Japan's Proposal for GTR 21 revision

prepared by Japan
@EVE60

24th & 27th March 2023

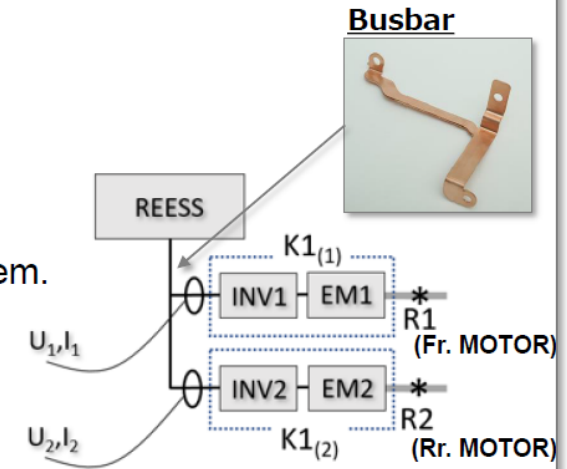
- Current requirement : Measure using an external measurement devices, and the accuracy requirement is $\pm 3\%$
- Reason for Proposal : There is a safety risk of fuel leakage when measuring the fuel flow rate by modifying the in-vehicle fuel piping.
- Proposal content : Since the on-board data of fuel flow rate satisfies the required accuracy of the external measurement device, it can be substituted.

This is the result of JAMA3 companies, verifying the difference between the external measurement device and the on-board data.

- The result of JAMA3 companies confirm that the on-board data is within $\pm 2\%$ against the external measurement device.
- This accuracy is well within the $\pm 3\%$ tolerance of external measurement device and can be guaranteed even when replaced with on-board data.

The fuel flow rate can be replaced with the on-board measurement data because it can satisfy the accuracy requirement.

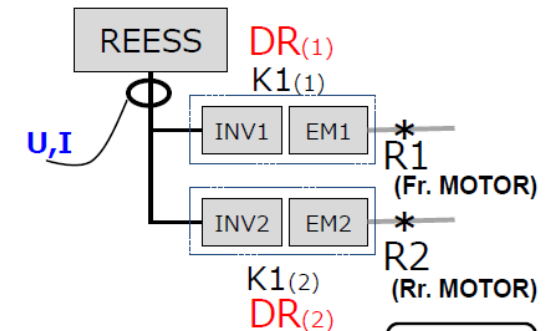
■ **Scene** Calculation of front and rear motor output in AWD system

■ **Problem**

- **Measurement** Busbar are used in integrated hybrid systems. Current/Voltage sensors are difficult to install in this type of system. Reason is lack of space and lack of electric safety.
- **Current text** Alternative method defined in 6.1.2. (demonstrate accuracy) doesn't work since no demonstration is feasible

■ **One of the possible solutions**

- Calculate R1/R2 branch power based on
 - (1) measured REESS power (U, I) before distribution and
 - (2) distribution ratio ($DR_{(1)}, DR_{(2)}$) by torque command value from CAN

Explained that since REESS power output is measured, slight deviations in front/rear allocations will have few effect on system output.

FIGURE 3. Efficiency maps of several IPM motors in EVs/HEVs [9], [12], [13]: (a) 2011 Sonata, (b) 2010 Prius, (c) 2012 Nissan Leaf, and (d) 2008 Lexus LS 600h.

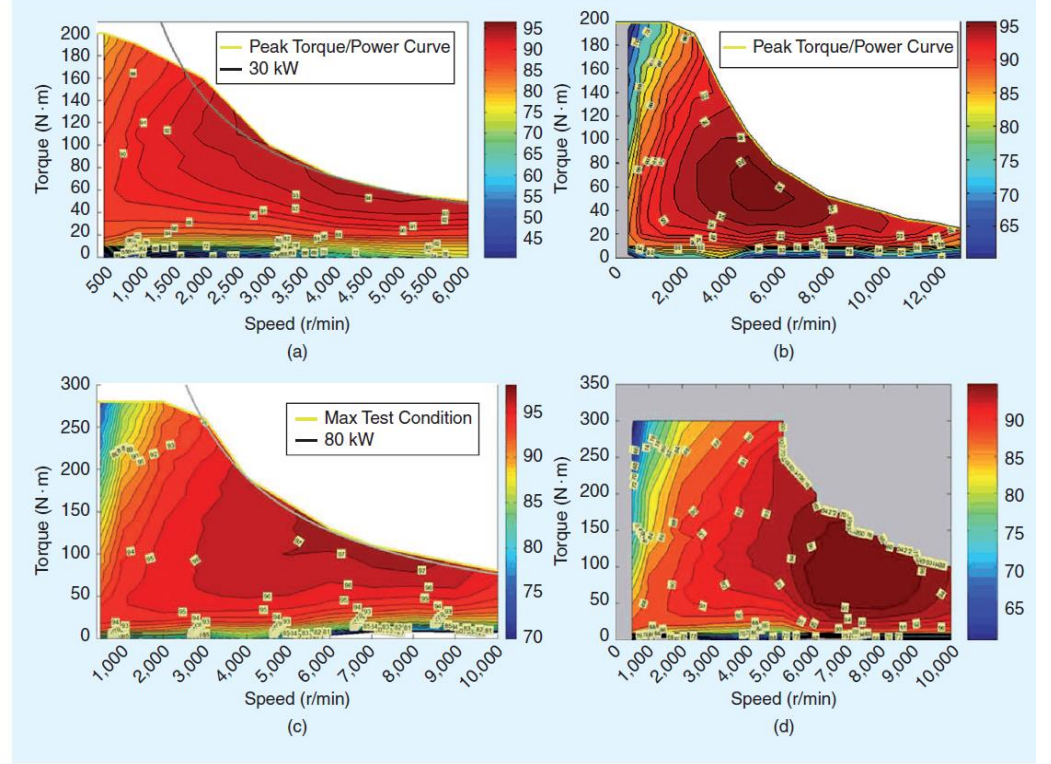
Even with the worst assumption, the impact on system output is ±0.11%, so the deviation in the distribution ratio does not need to be considered.
 → Propose to utilize on-board data of motor torque in hybrid vehicle.

FIGURE 3. Efficiency maps of several IPM motors in EVs/HEVs [9], [12], [13]: (a) 2011 Sonata, (b) 2010 Prius, (c) 2012 Nissan Leaf, and (d) 2008 Lexus LS 600h.

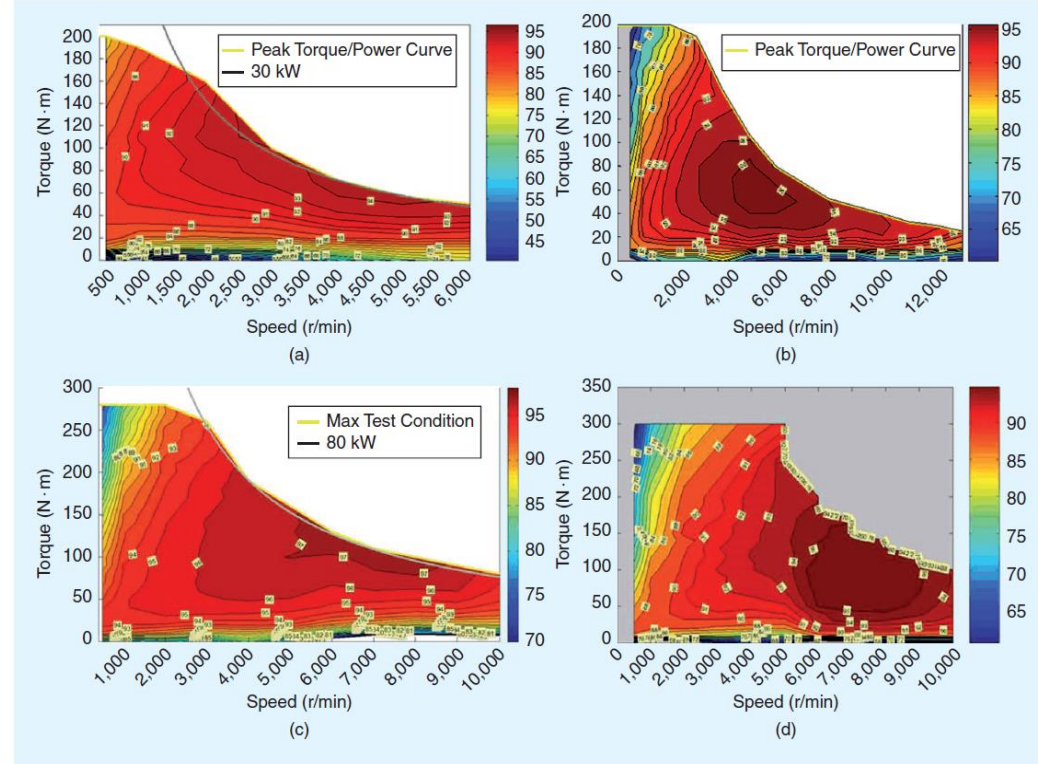
For BEV, even under the worst-case scenario, the impact is ±0.54%.

➔ Propose to utilize on-board data of motor torque in BEV.
